Re: Response and Development Work Plan  
Addendum – Comment Response Letter  
Area A: Sub-Parcel A8-1  
Tradepoint Atlantic  
Sparrows Point, MD 21219

On behalf of EnviroAnalytics Group, LLC (EAG), ARM Group Inc. (ARM) is pleased to provide the following responses to comments received from the Maryland Department of the Environment (MDE) in an email dated October 22, 2018. The MDE provided comments regarding the previous Response and Development Work Plan (RADWP) Addendum submission (dated October 11, 2018) for Sub-Parcel A8-1 (the Site) of the Tradepoint Atlantic property located in Sparrows Point, Maryland. Based on the minor nature of the comments, the Sub-Parcel A8-1 RADWP Addendum itself will not be updated, but this Comment Response Letter serves the purpose of providing additional details as requested by the MDE. Relevant attachments including development plan figures and details are referenced herein. Responses to the MDE comments are provided below; the original comments are included in italics with responses following.

**STORMWATER MANAGEMENT  
FINAL DESIGN - PROPOSED  
CONDITIONS DRAINAGE AREA MAP  
GOTHAM GREENS**

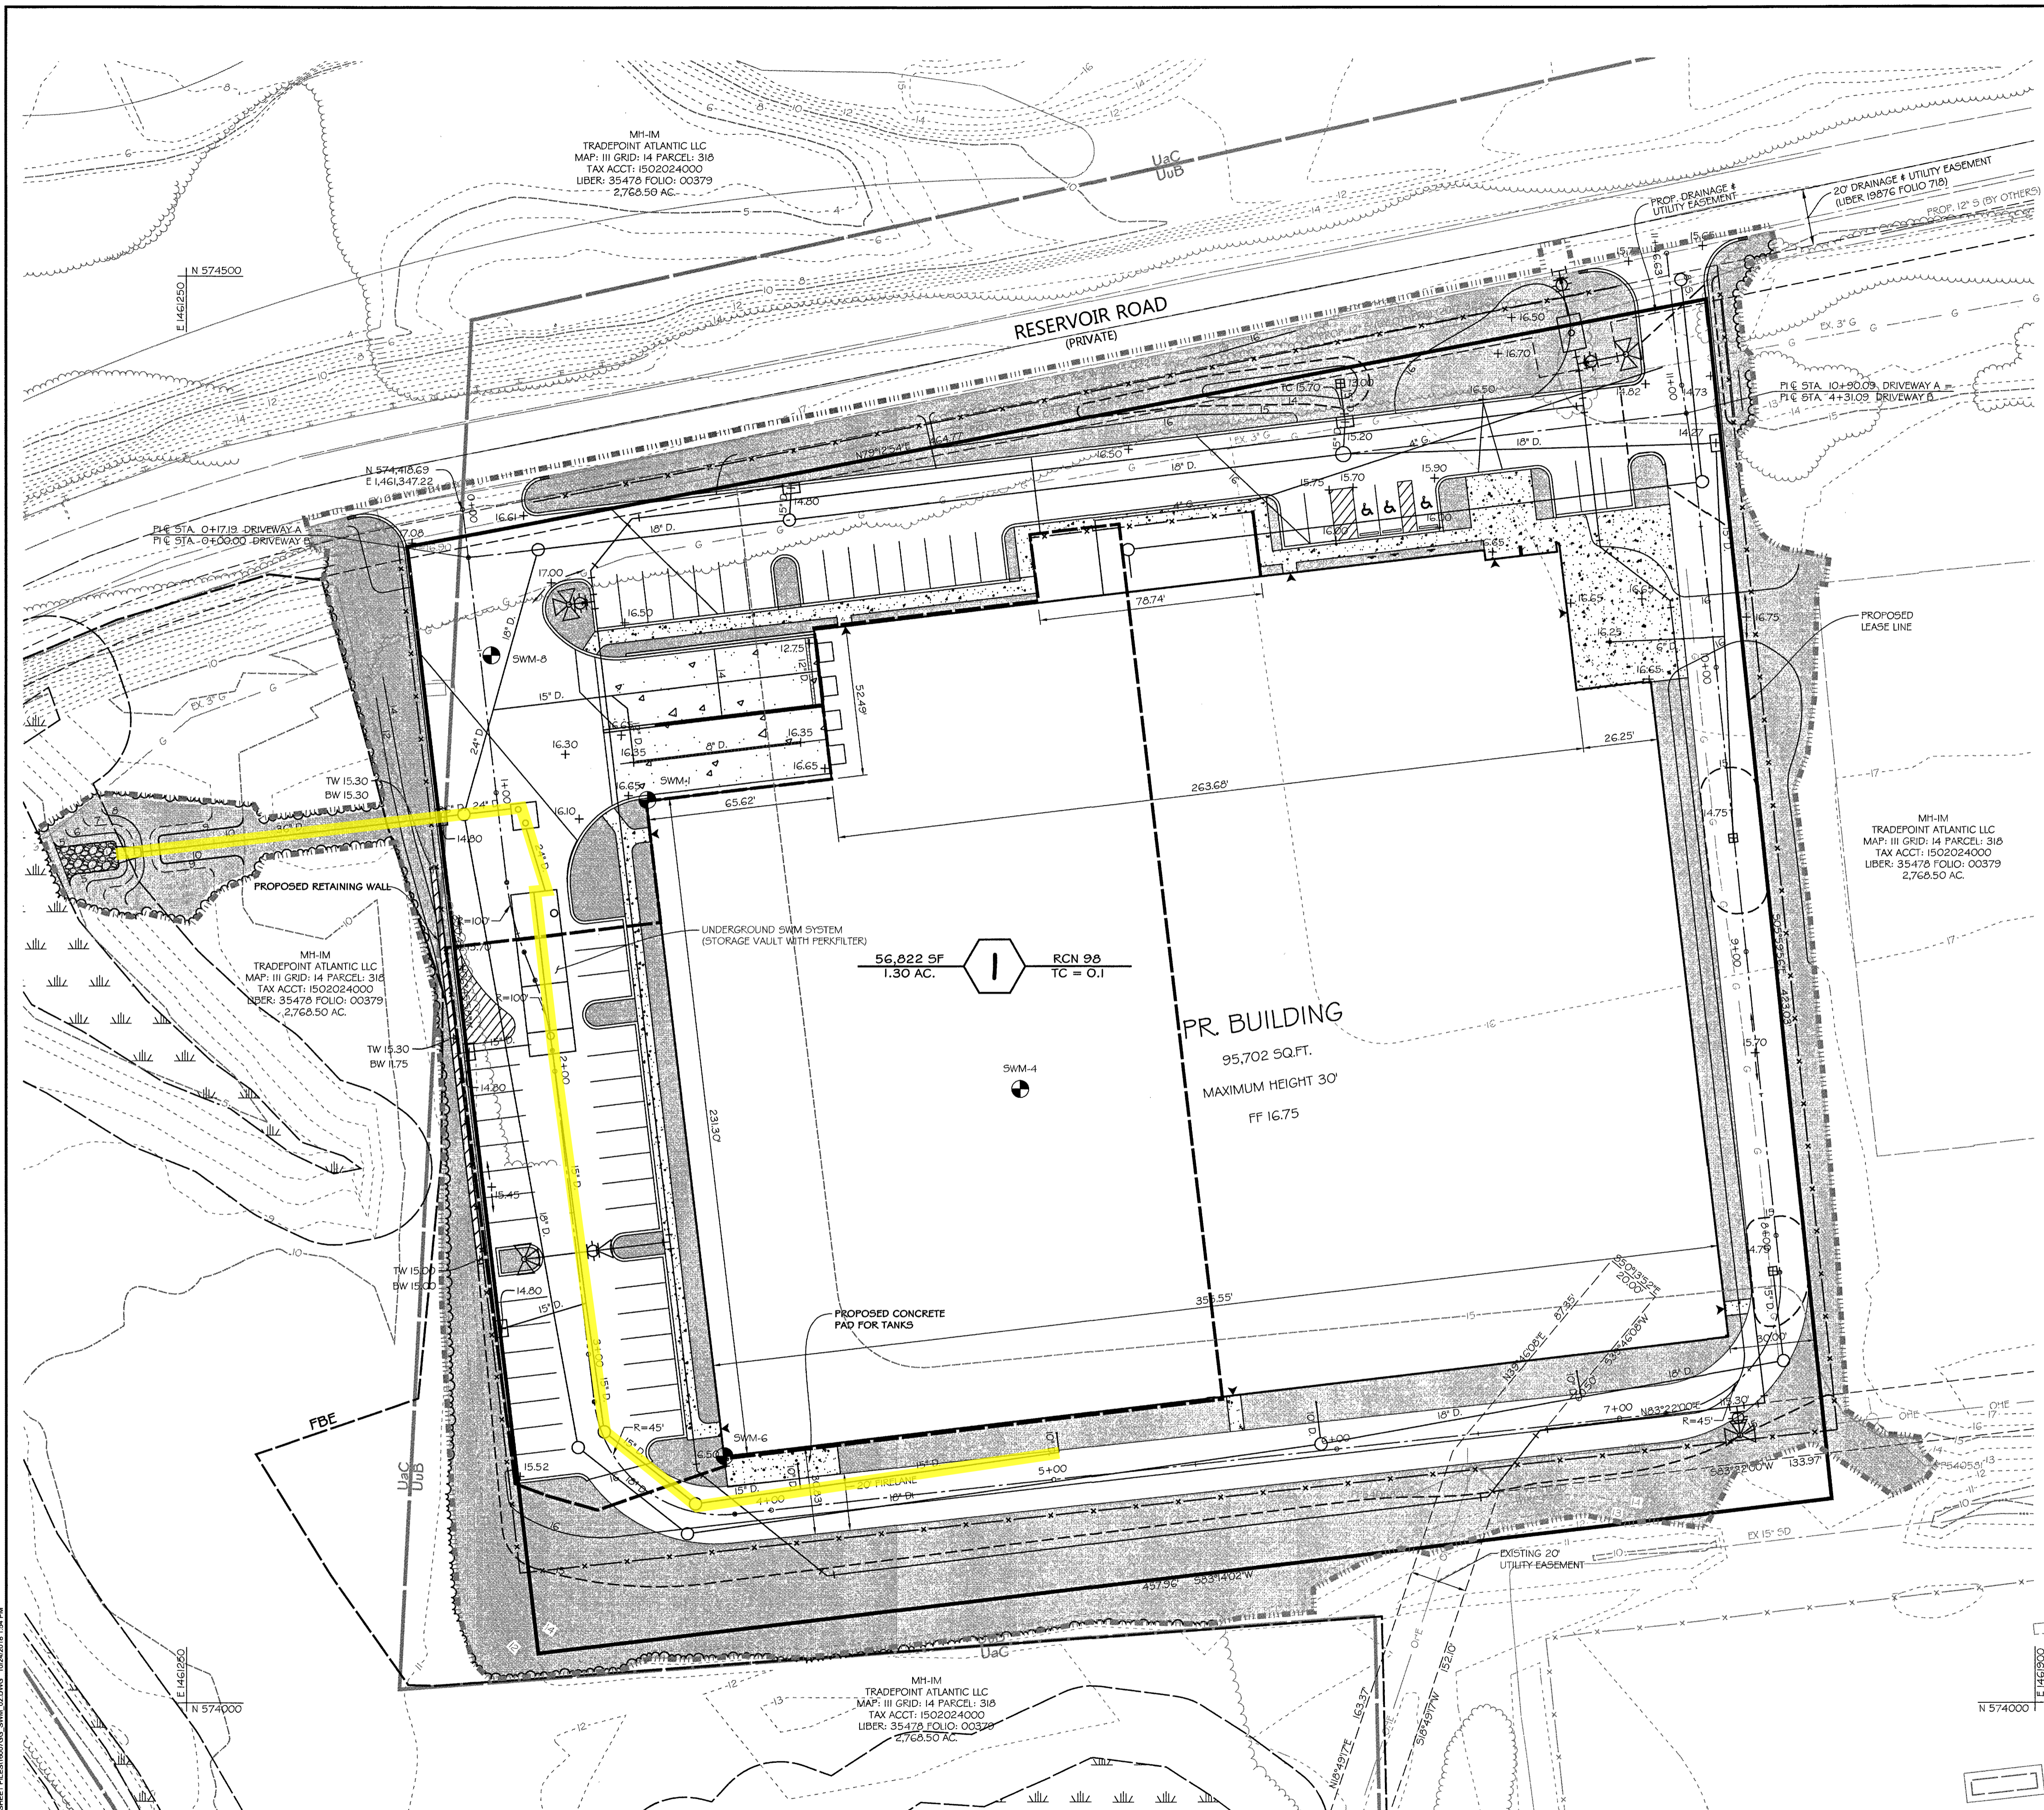
1. *Please submit a figure that depicts construction details for the new stormwater outfall on the western portion of the property.*

As requested, additional construction details for the new stormwater outfall proposed to the west of the main development area are provided in **Attachment 1** and **Attachment 2**. The drawings in **Attachment 1** show pervious and impervious areas around the Site and the stormwater drainage network that leads to the new proposed outfall. **Attachment 2** provides a storm drain profile for the main line leading to the new outfall (highlighted in yellow in **Attachment 1**) including the gradient of the gravity flow stormwater system as well as the length, width, and thickness of the riprap protection surrounding the outfall.

**STORM DRAIN M8 TO CUT-IN 2**  
SCALE: HORIZ. 1"=30'  
VERT. 1"=5'

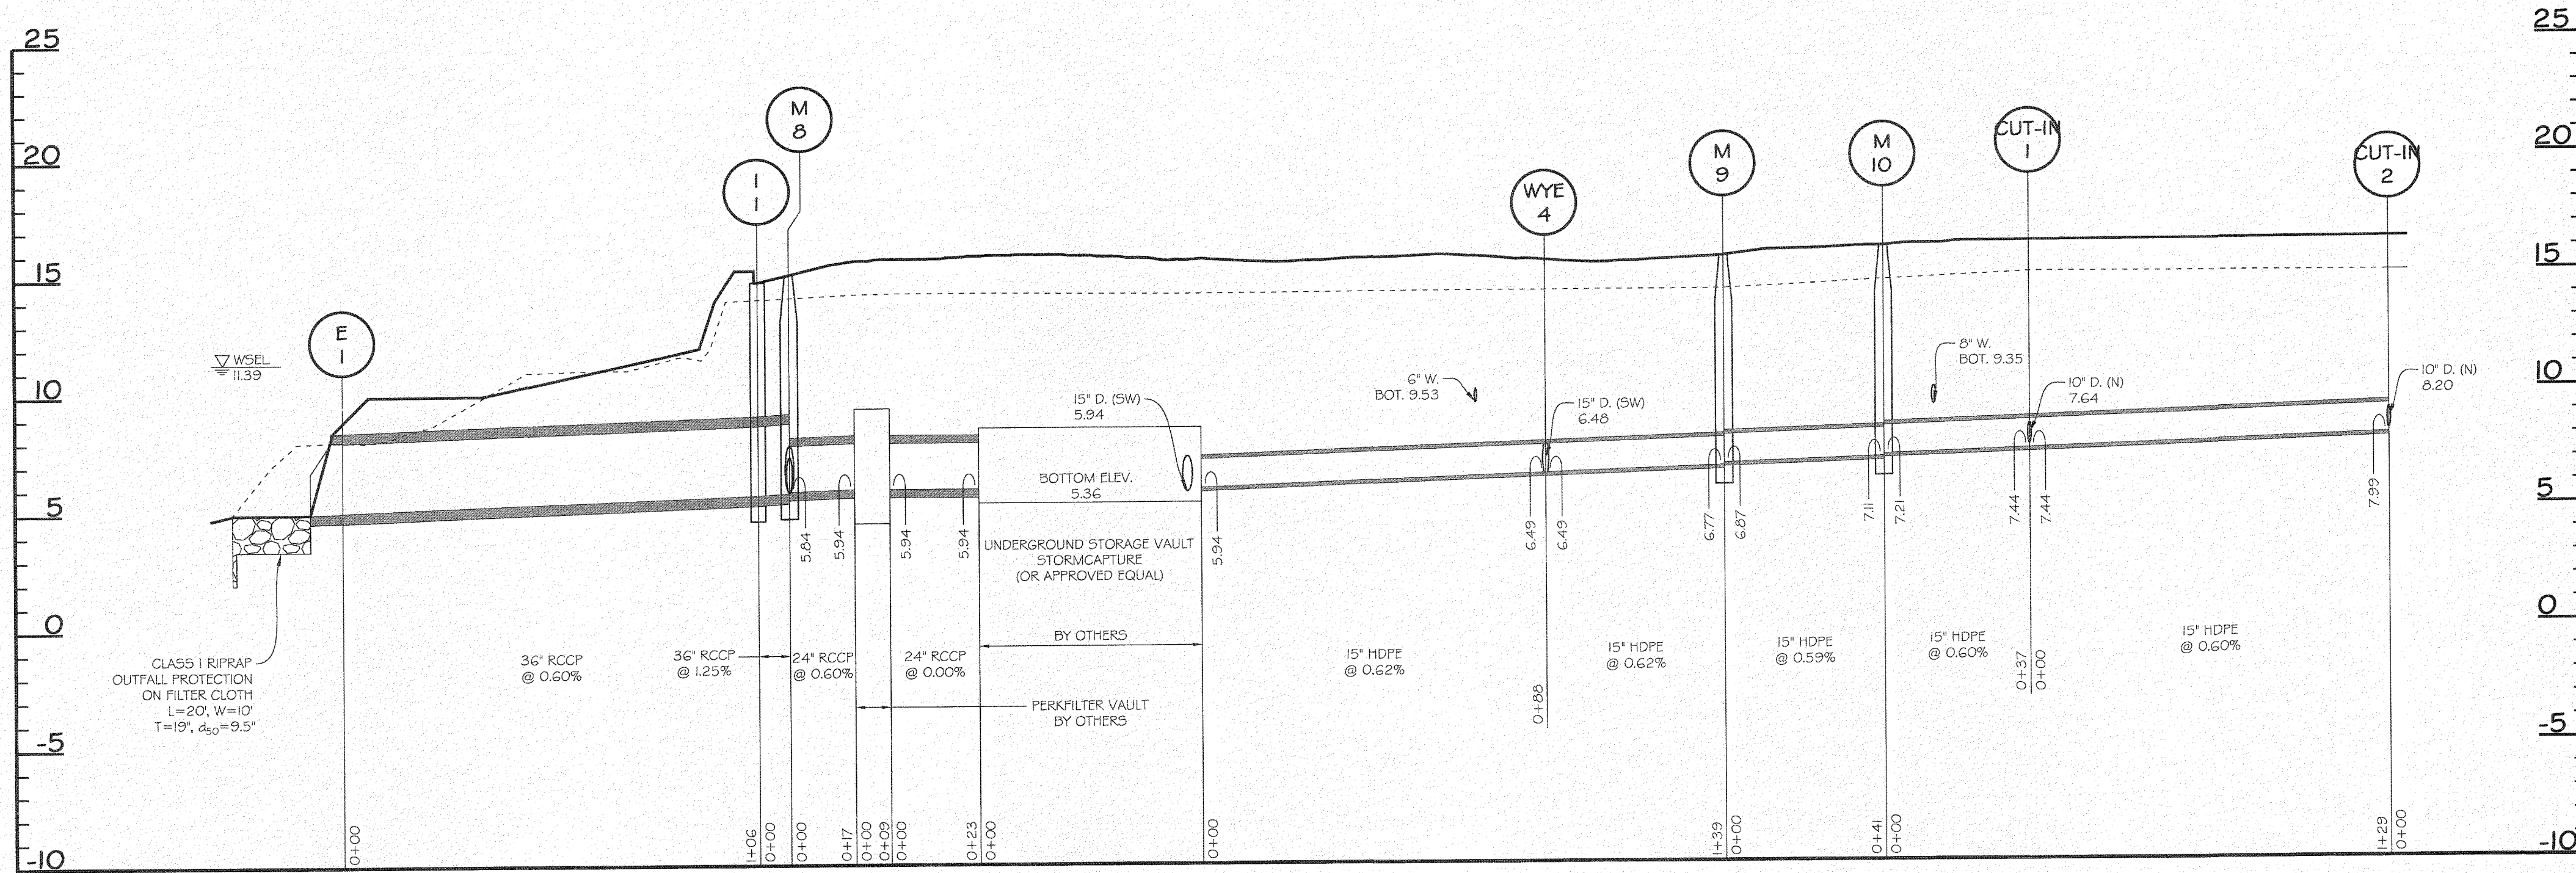
2. *Determine if this stormwater outfall will intersect the groundwater table.*

According to development plans provided by Tradepoint Atlantic, the stormwater outfall and portions of the drainage network appear to be proposed to be installed below the groundwater table. **Attachment 2** shows the stormwater outfall and drainage network profile. Since the potentiometric surface in the vicinity of the proposed outfall was approximately 9 feet above mean sea level (amsl) (refer to the Parcel A8 Phase II Investigation Report) and the outfall has a proposed bottom elevation of approximately 5 feet amsl, the outfall will likely be submerged.
